REVISED RESPONSE TO REQUEST FOR ADDITIONAL INFORMATION

APR1400 Design Certification

Docket No. 52-046

RAI No.: 244-8326
SRP Section: 09.03.03 – Equipment and Floor Drainage Systems
Application Section: 9.3.3
Date of RAI Issue: 10/14/2015

Figure 1. Turbine Generator Building Drain System

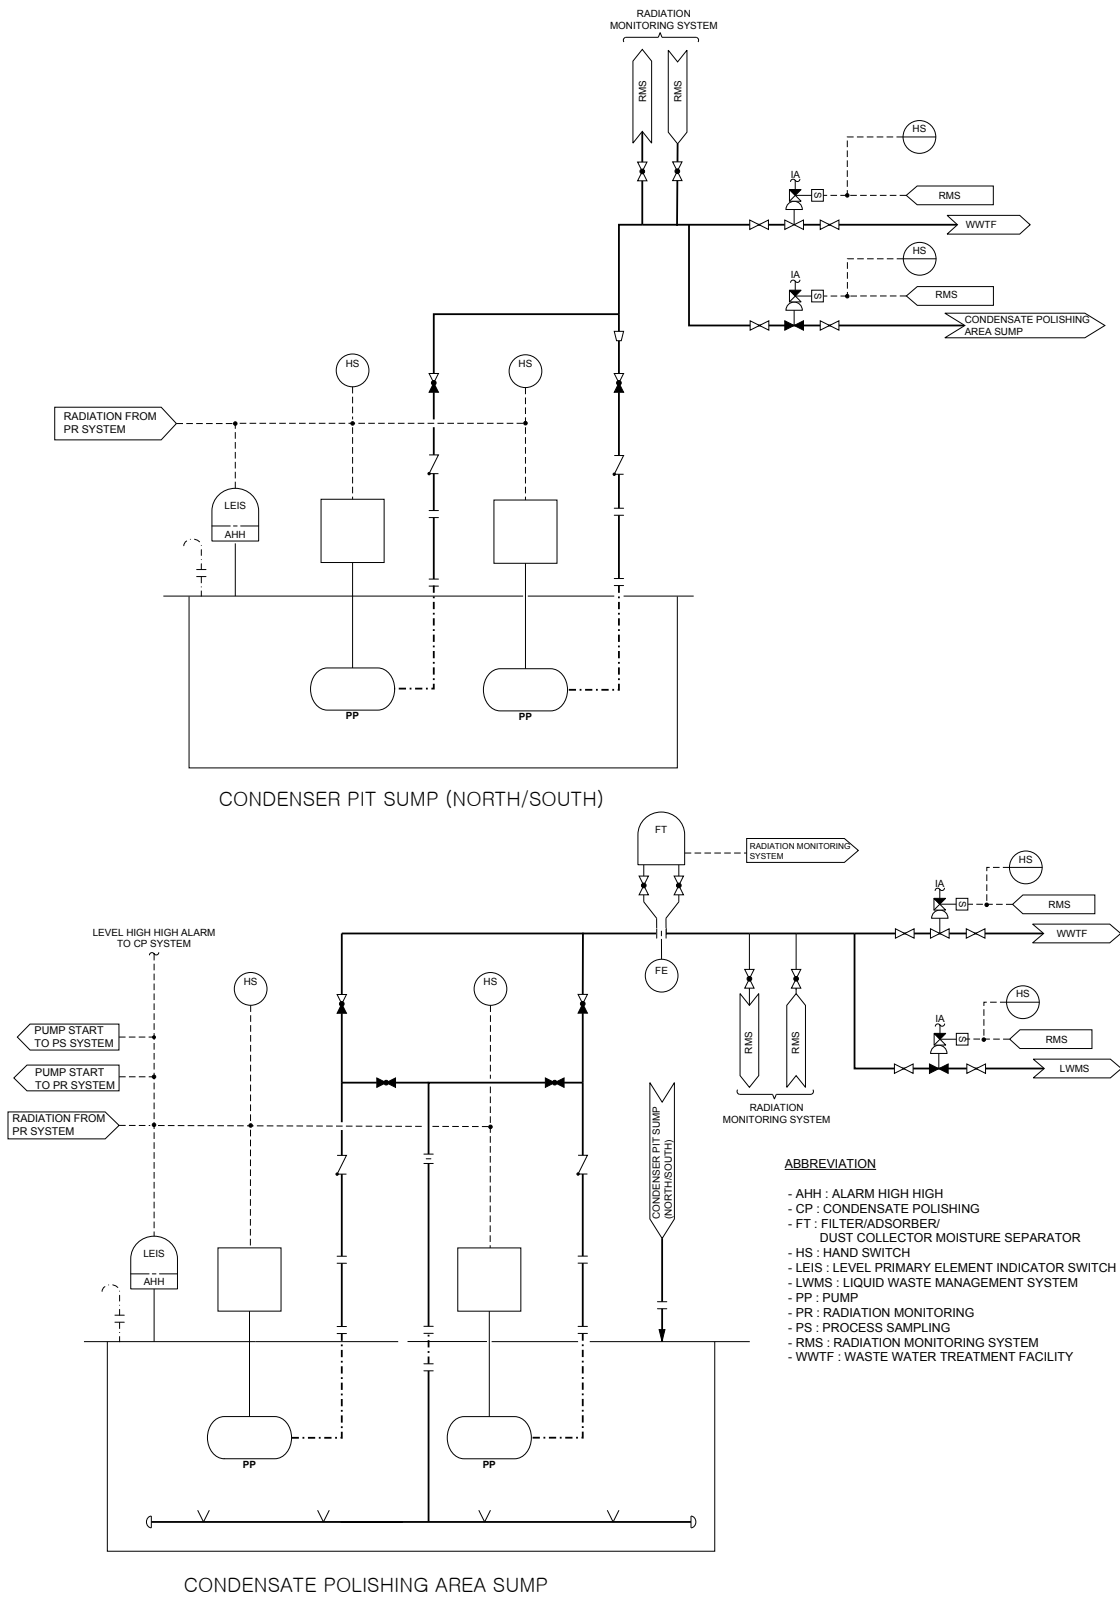
DCD Tier 2, Figure 9.3.3, “Equipment and Floor Drainage System,” depicts the EFDS including the radioactive subsystem in the auxiliary building. However, this figure only shows certain portions of the EFDS, specifically the radioactive portions in the auxiliary and compound buildings. This figure is missing information depicting the reactor containment building subsystems, the turbine generator building subsystems, and the identification of the safety-related and nonsafety-related portions of the EFDS. In addition, the figure does not show the interconnection of the turbine generating building sump pump discharge between the liquid waste management system (LWMS) and the waste water treatment facility (WWTF).

The applicant is requested to provide the above information in DCD Tier 2, Table 3.2-1, Figure 9.3.3, and Section 9.3.3, in order for the staff to adequately review the EFDS design against GDC 60.

The turbine generator building drain system consists of the condenser pit sumps (north/south) and a condensate polishing area sump. The figure 1 shows the interconnection of the turbine generator building sump pumps between the LWMS and the WWTF.

All sump pumps discharge into the WWTF when radioactivity of fluid is below a predetermined setpoint. The discharge from the condensate polishing area sump is monitored for process radiation. When contamination level is detected at or exceeding a predetermined setpoint, the operating sump pump is stopped automatically by the RMS signal. The discharge valve to the WWTF is closed and the discharge valve to the LWMS is opened. Then, the sump pump is manually started. The flow is then diverted to the LWMS.

The discharges from the condenser pit sumps are monitored for process radiation. When contamination level is detected at or exceeding a predetermined setpoint, the operating sump pumps are stopped automatically by the RMS signal. The discharge valve to the WWTF is closed and the discharge valve to the condensate polishing area sump is opened. Then, the sump pump is manually started. The flow is then diverted to the condensate polishing area sump and finally to the LWMS.

The DCD will be revised to state that the COL applicant is to provide the classification of structures, systems, and components and the flow diagram for turbine generator building drain system.
